Product Change Notification

Change Notification #: 114840 - 02
Change Title: Intel® Omni-Path Host Fabric Interface Adapter 100 Series 1 Port PCIe x16 Standard 100HFA016FS

PCN 114840-02, Product Design, Label, Product Material

Manufacturing Process Change for QSFP Cage Attach, Regulatory Label update for Korea/Taiwan, and Firmware Upgrade

Change 2C: Package labels will be changed to accommodate the Korean Regulatory requirements

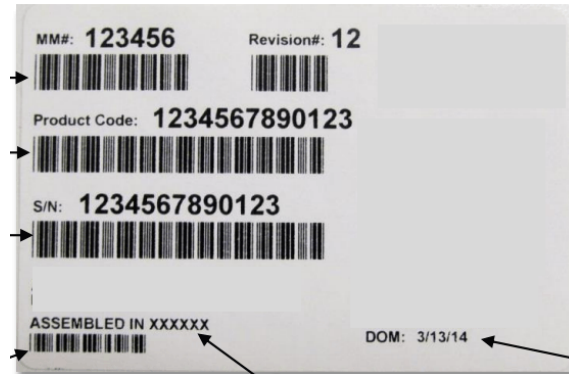
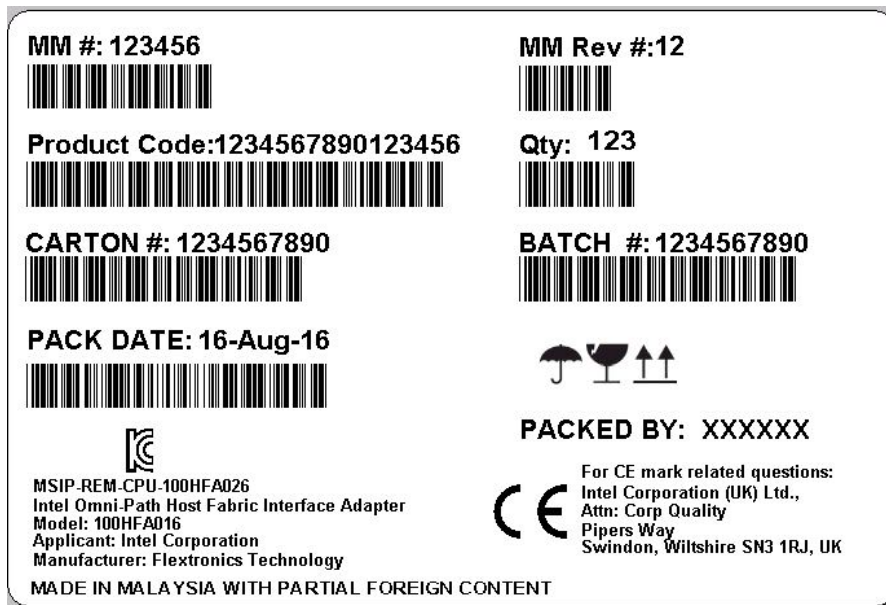
The following data will be added to the individual box and non-serialized carton packaging labels for Korean requirements:

1. KC Mark
2. Korean Registration Number: MSIP-REM-CPU-100HFA026
3. Equipment Name: Intel Omni-Path Host Fabric Interface Adapter
4. Regulatory Model Number: 100HFA016
5. Applicant: Intel Corporation
6. Manufacturer: Flextronics Technology
